1st Further Information

**Proposed Temporary Warehouse (Excluding Dangerous Goods Godown) with Ancillary Facilities
for a Period of 3 Years in "Recreation" Zone, Various Lots in D.D. 78 and Adjoining
Government Land, Lin Ma Hang, Ta Kwu Ling North, New Territories**

(S.16 Planning Application No. A/NE-TKLN/86)

Responses-to-Comments

Annex 1 – Photos showing the existing engineering channel at the Site

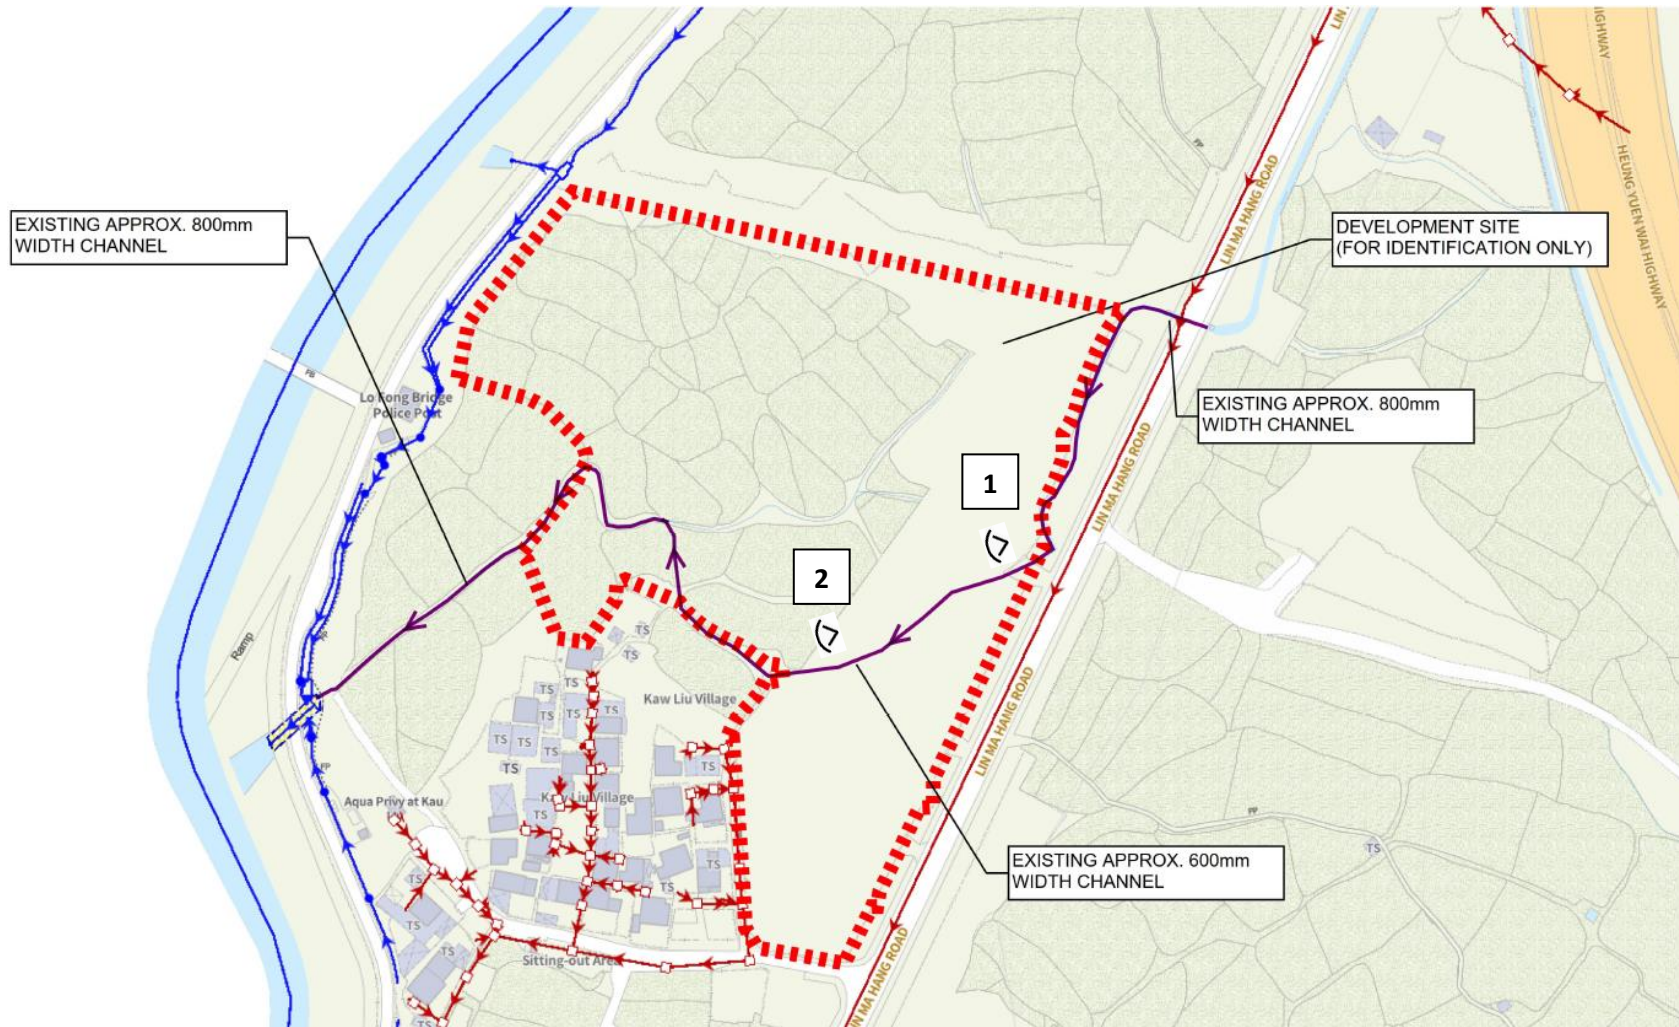
Departmental Comments		Applicant’s Responses
1. Comments of the Director of Agriculture, Fisheries and Conservation (DAFC)		
(a)	Based on the aerial photo, the subject site is largely vacant with a watercourse located within the subject site. The applicant should clarify whether there will be any impact to the watercourse and measures to be proposed for our further consideration.	<p>It is noted that an existing engineering channel is located within the application site (the Site) (site photos at Annex 1 refers). The said channel is proposed to be diverted as illustrated in Figure 3B of the revised Drainage Impact Assessment (DIA) (Annex 2).</p> <p>Please also be advised that with the implementation of the proposed drainage system and upgrade of the existing downstream U-channels, no adverse impact to the existing channel is anticipated.</p>

DRAWING NUMBER
FIGURE 3B

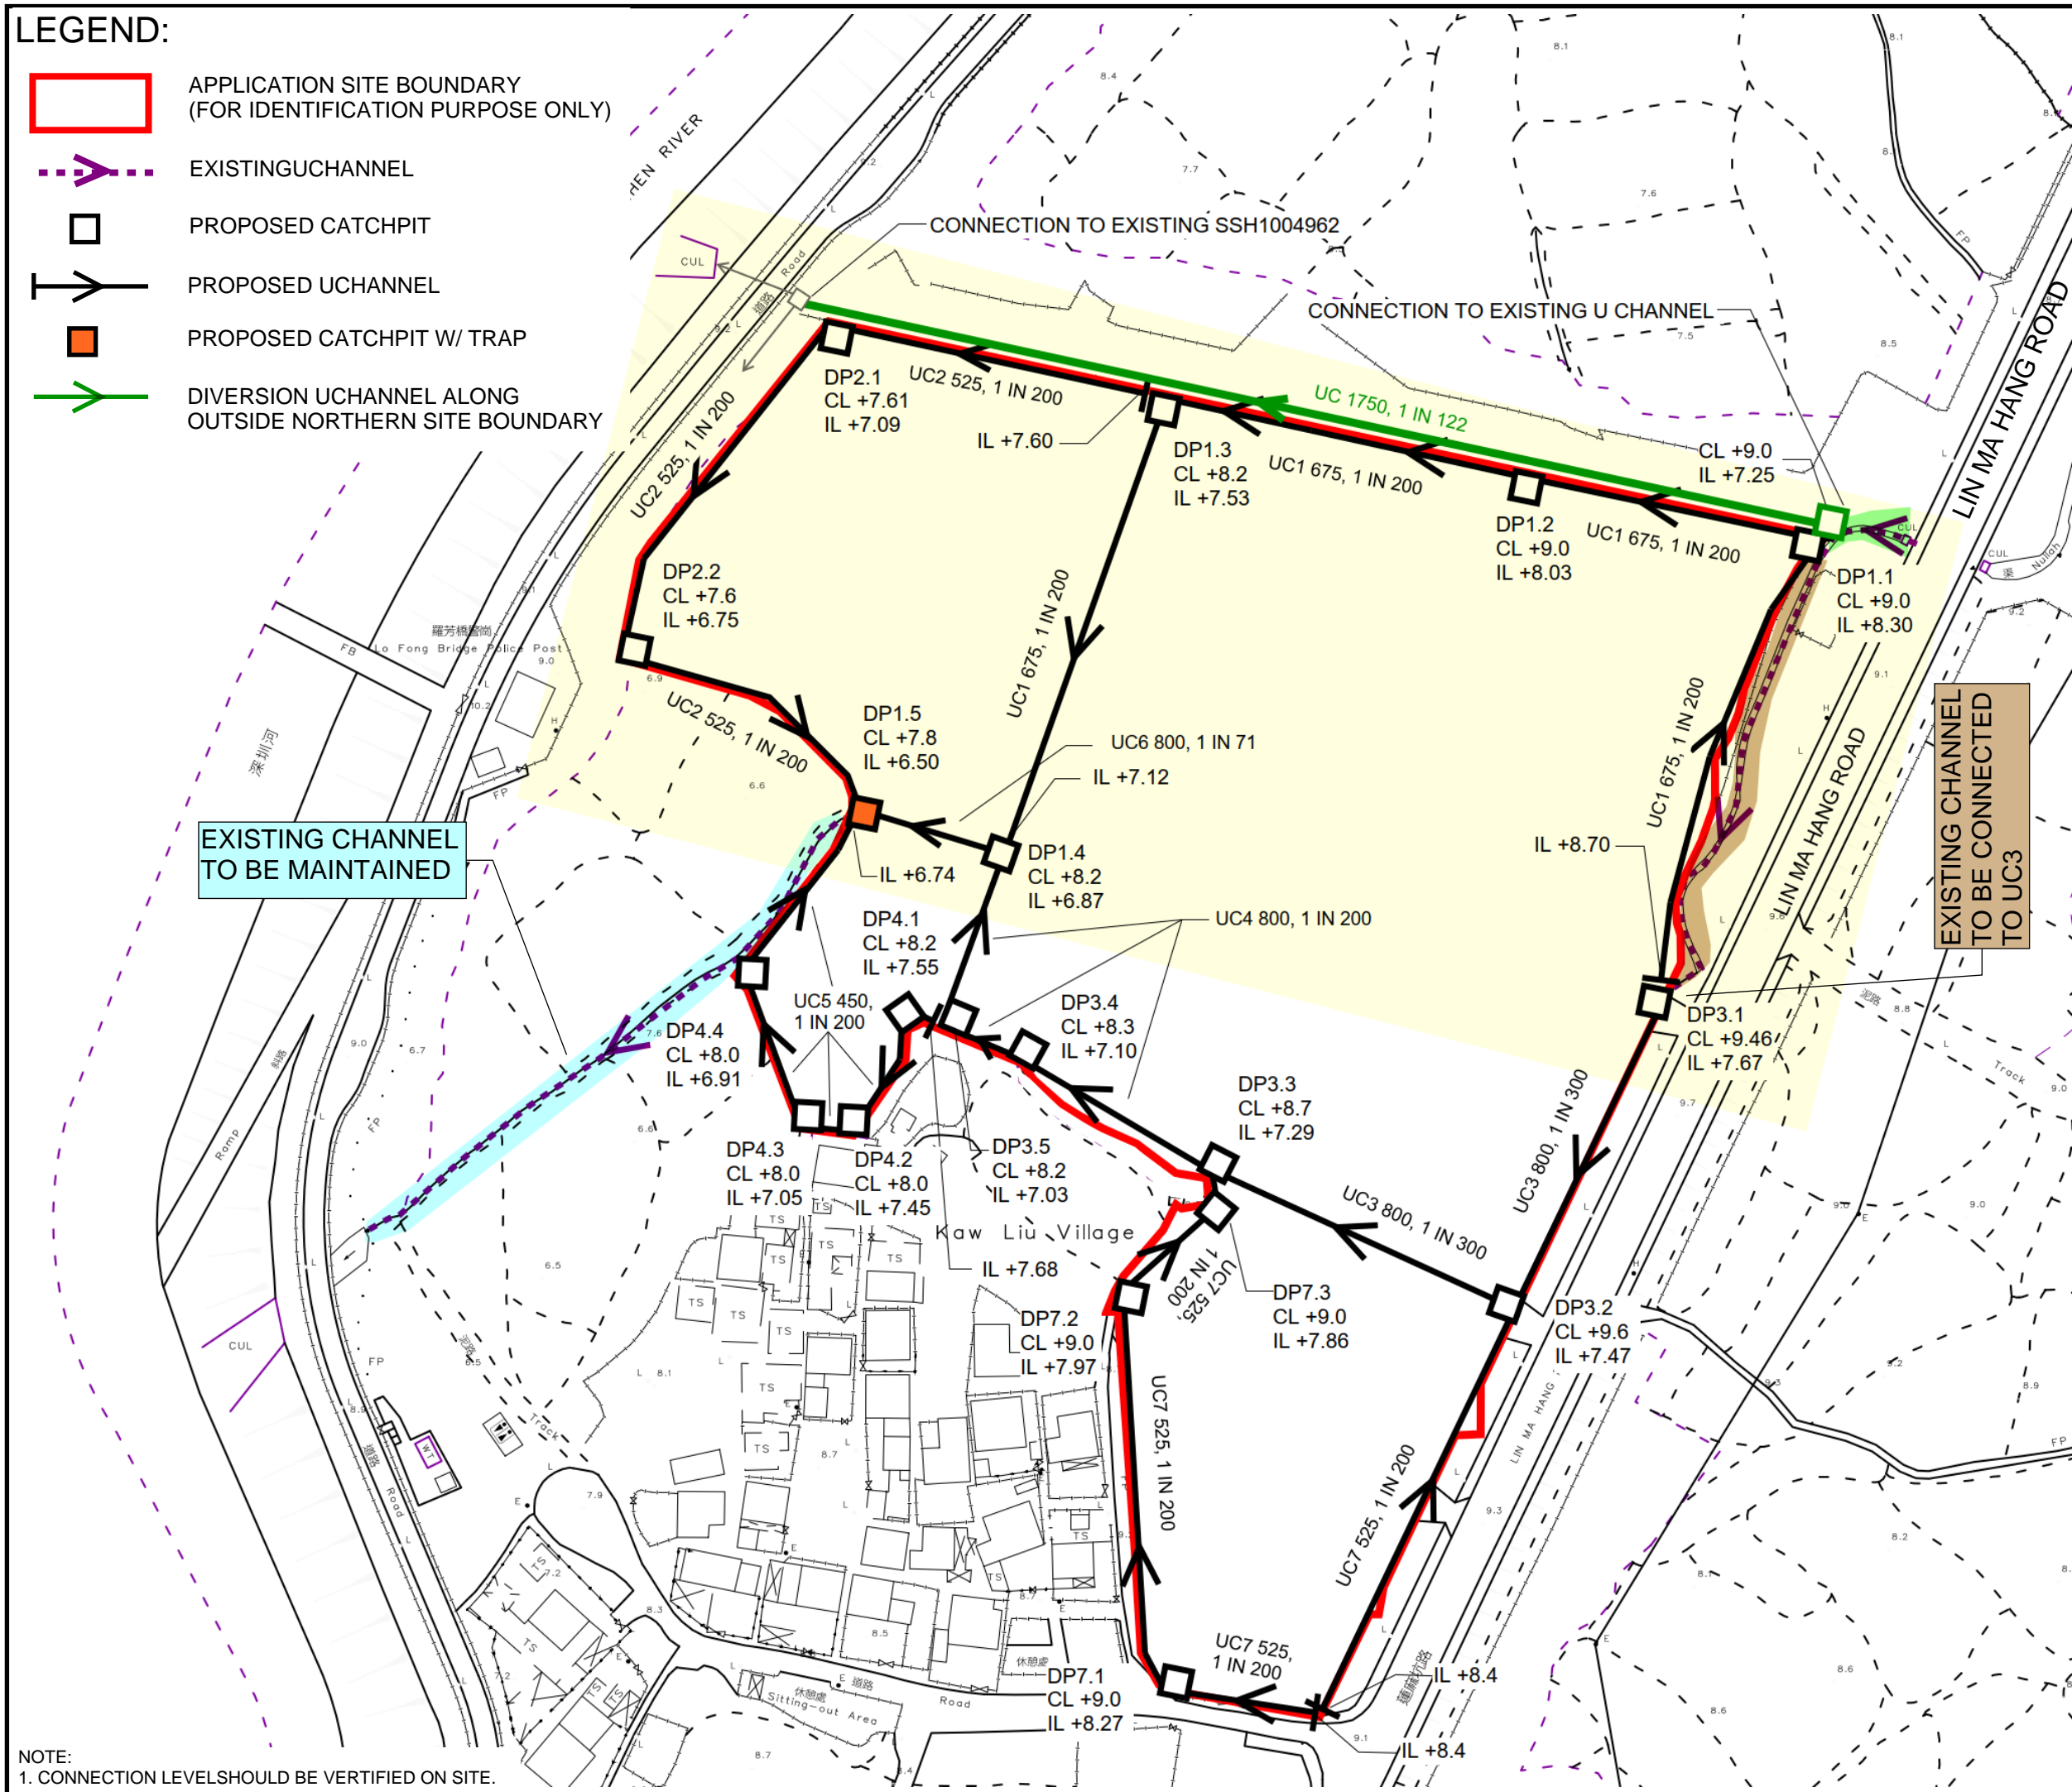
2. Comments of the Chief Engineer/Mainland North, Drainage Services Department (CE/MN, DSD)		
(a)	There are pre-existing drainage channels located on government land within the site and along the planned access road in the north. These channels currently receive flows from outside the site and direct them downstream. The proposed drainage plan involves the removal of these existing channels and relies on the newly proposed channels situated on private lots to accommodate the upstream flow. This approach would require the applicant to undertake additional maintenance efforts and could potentially expose the site and the adjacent areas to unnecessary flood risks.	<p>Further to the discussion with DSD, a 1,750 mm channel is proposed for diversion of the upstream channel to divert to existing manhole SSH1004962 at the north-west side of the Site. Such that the channel is located on government land as far as possible.</p> <p>DSD also commented to connect the site drainage to the existing downstream channel in the southwest instead of the proposed 1,750 mm. As the upstream flow is diverted, the overall flow to the downstream channel is reduced. Therefore, no adverse drainage impact to the downstream channel is anticipated.</p>

<p>To address this concern, it is recommended to implement a diversion scheme that includes drainage alignments on government land wherever feasible. This approach would allow the government to continue carrying out necessary maintenance works effectively. A suggested alignment is appended below for consideration.</p> 	<p>The proposed diversion and calculation are shown in Figure 3B and Appendix A of the revised DIA respectively for your perusal (Annex 2).</p> <p>DSD also suggested to install railing at the top of 1,750 mm channel if cover is not provided for safety consideration.</p>

4.1.1 The existing upstream U-channel is proposed to be diverted starting at the northeast of the application site and connect to proposed 1750mm channel along the northern site boundary. It would discharge to the existing manhole SSH1004962 and eventually fall to Shenzhen River. The design calculations of proposed UChannels are shown in **Appendix A**.

4.3.2 The alignment, size, gradient and details of the proposed drains are shown in **Figure 3**.
